Final
**Remedial Investigation/Feasibility Study
Work Plan**

for
AOC I and AOC R

at the
**Former U.S. Naval Ammunition Support Detachment (NASD)
Vieques Island, Puerto Rico**

August 2004

Figure 4-4
AOC R Surface Soil Sample Locations
Former NASD, Vieques, Puerto Rico

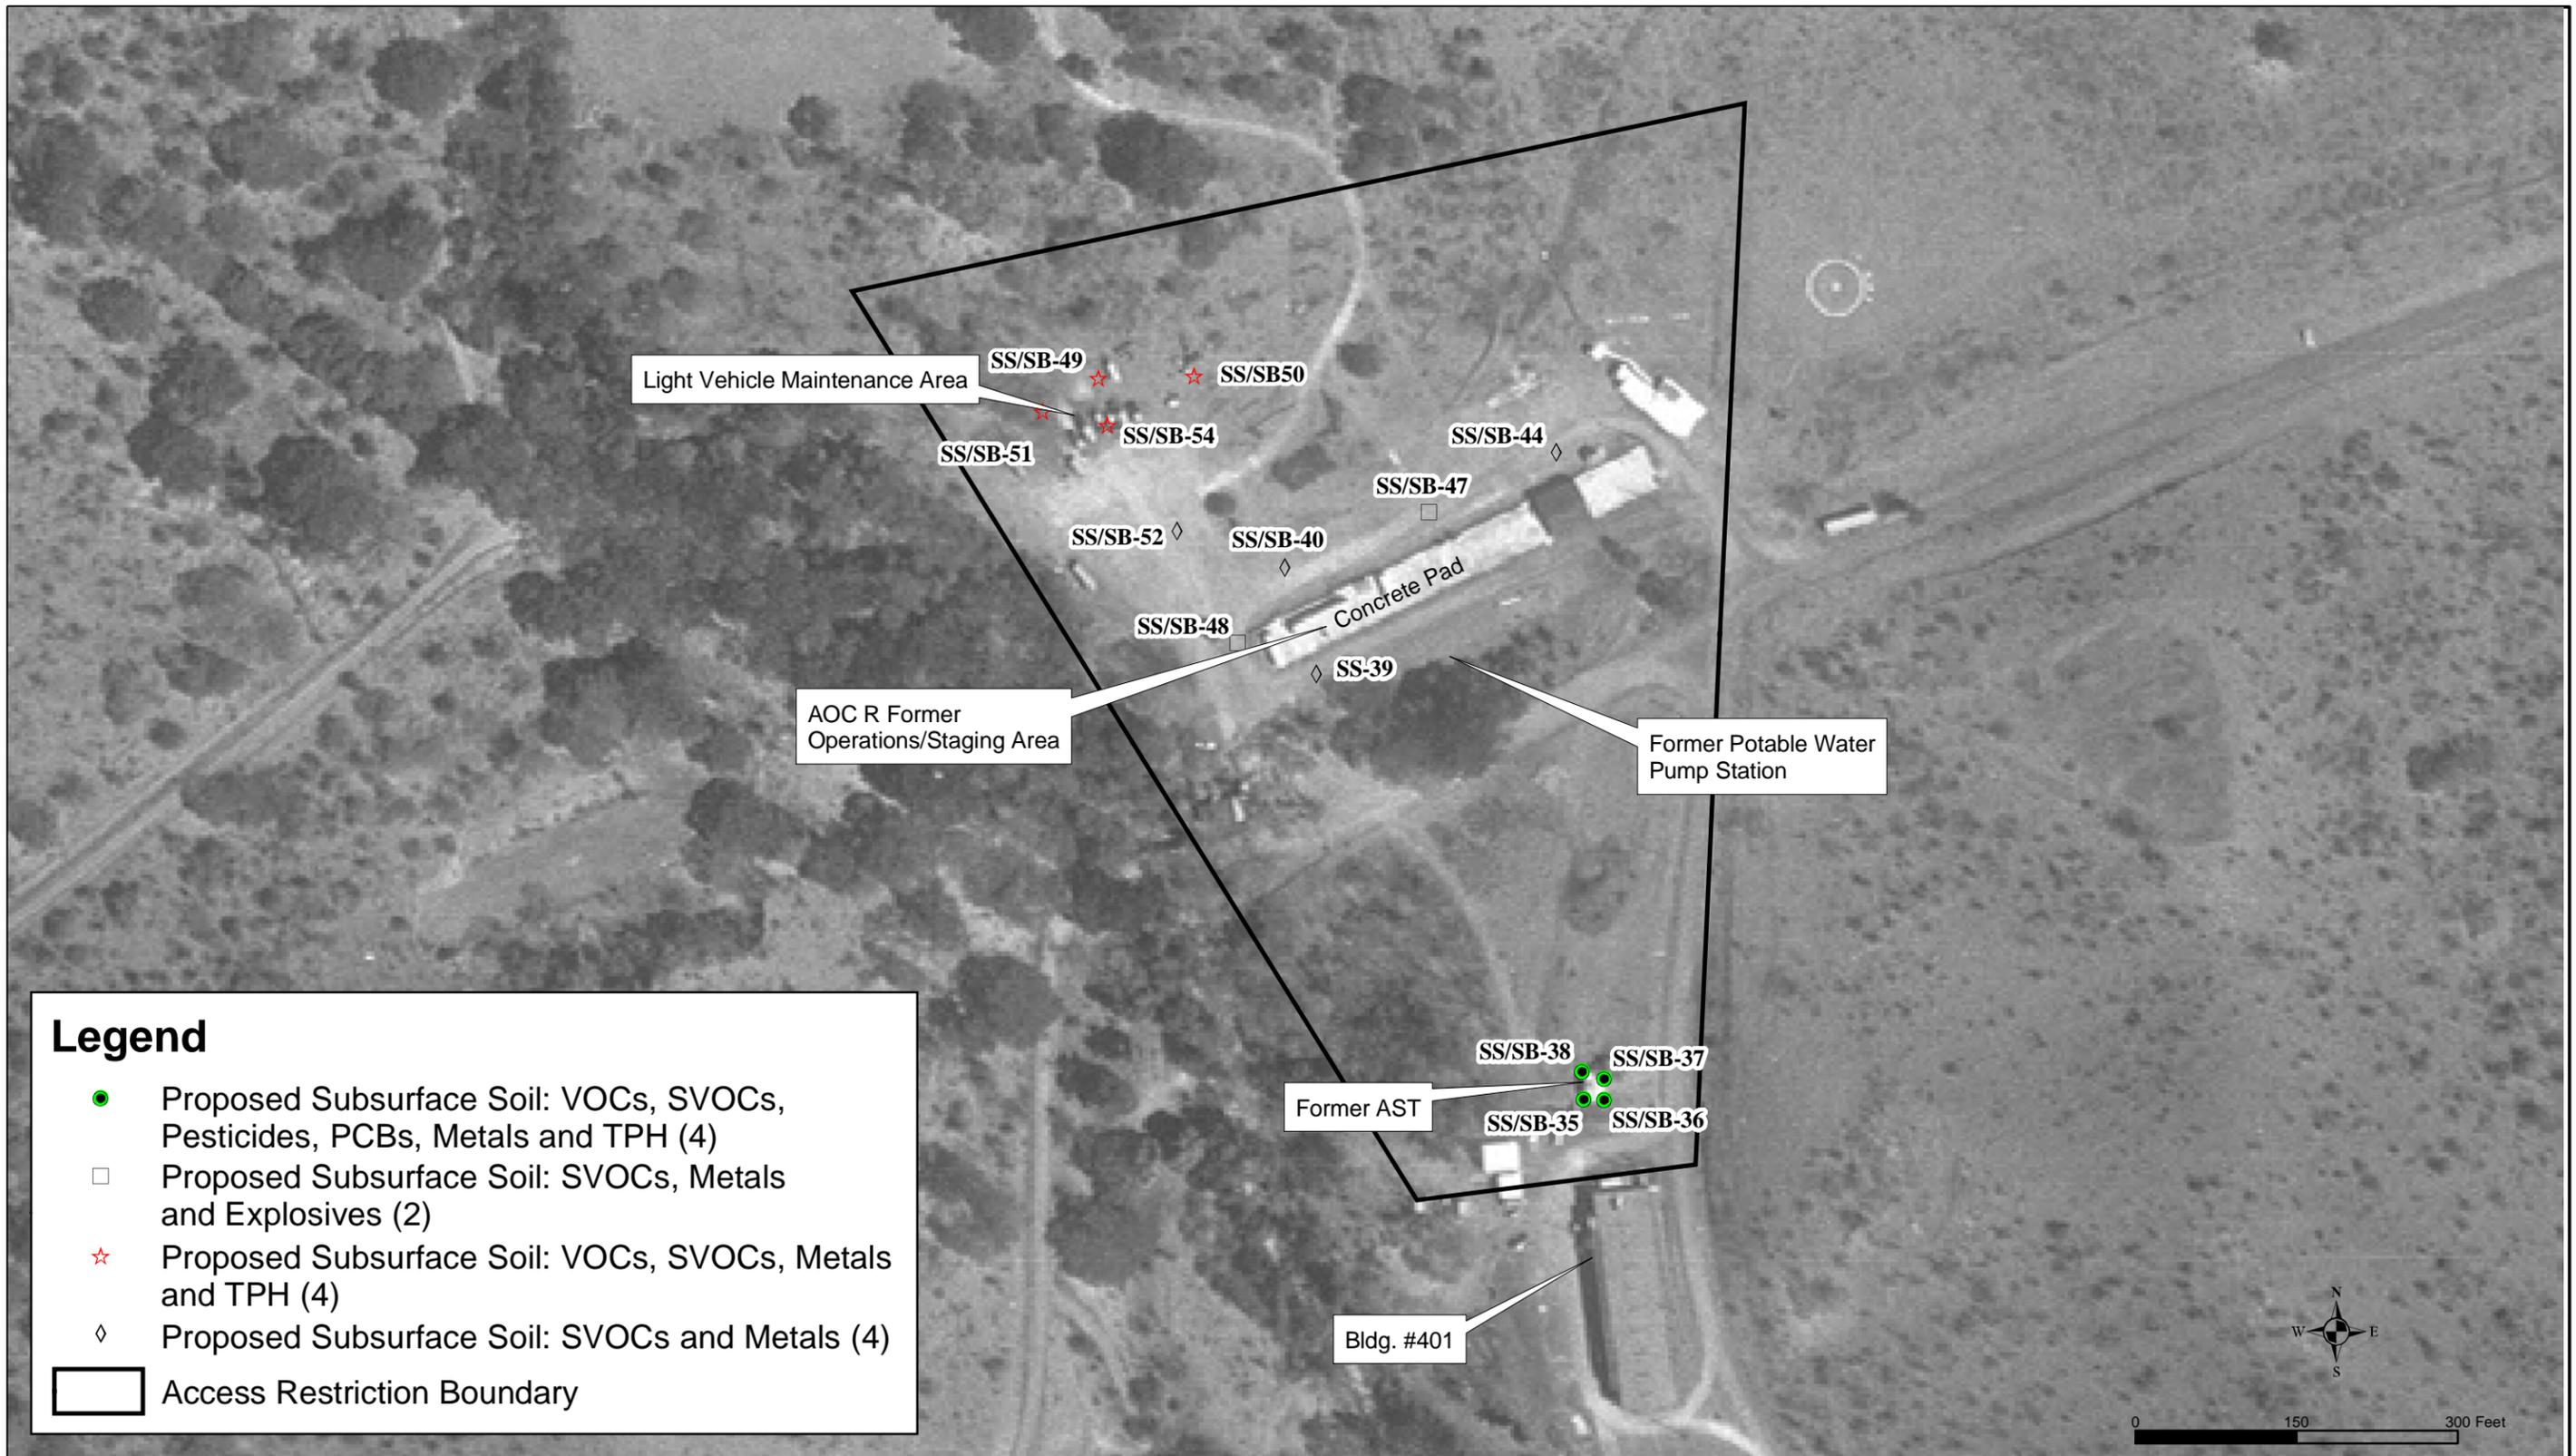
Figure 4-3 – If the AST tank foundation or containment berm area is earthen then the 4 soil samples should be collected from the foundation area and berm containment areas. If the tank containment and foundation are constructed of metal or concrete then the soil samples should be collected from the nearest visually impacted soils or from drainage areas as close to the tank containment area as possible. Also shallow soil samples should be collected from the area where light vehicle maintenance activities were conducted. Also if sediment and surface water is present in this depression, upstream, midstream and downstream surface water and sediment samples should be collected from the apparent stream due west of the site. Analyses should include those parameters measured in site soils as well as total organic carbon and grain size for sediment and pH and hardness for surface water. A staff gauge should be installed and surveyed to determine the elevation of the stream water level relative to groundwater measured at the site.

- a) The sample locations have been revised. Section 4.3.2.4, first sentence, has been edited to read: “Four surface soil and four subsurface soil samples will be collected adjacent to the former AST south of Highway 200 for TPH and SVOCs. Figure 4-4 has been edited to portray the location change.

- b) The area was used for light vehicle maintenance activities, such as oil changes. This is stated in Section 2.1.2, and shown on Figure 4-4. The best aerial photograph of this area appears to be the 1967 photo. Section 2.1.2, sentence 4, has been edited to refer the reader to the figure showing the maintenance area.

Seven surface soil samples will be collected in the vehicle maintenance area as shown on Figure 4-4. No sediment or surface water is present within the access restriction boundary of AOC R, and the ephemeral stream to the west is dry except during rain events.
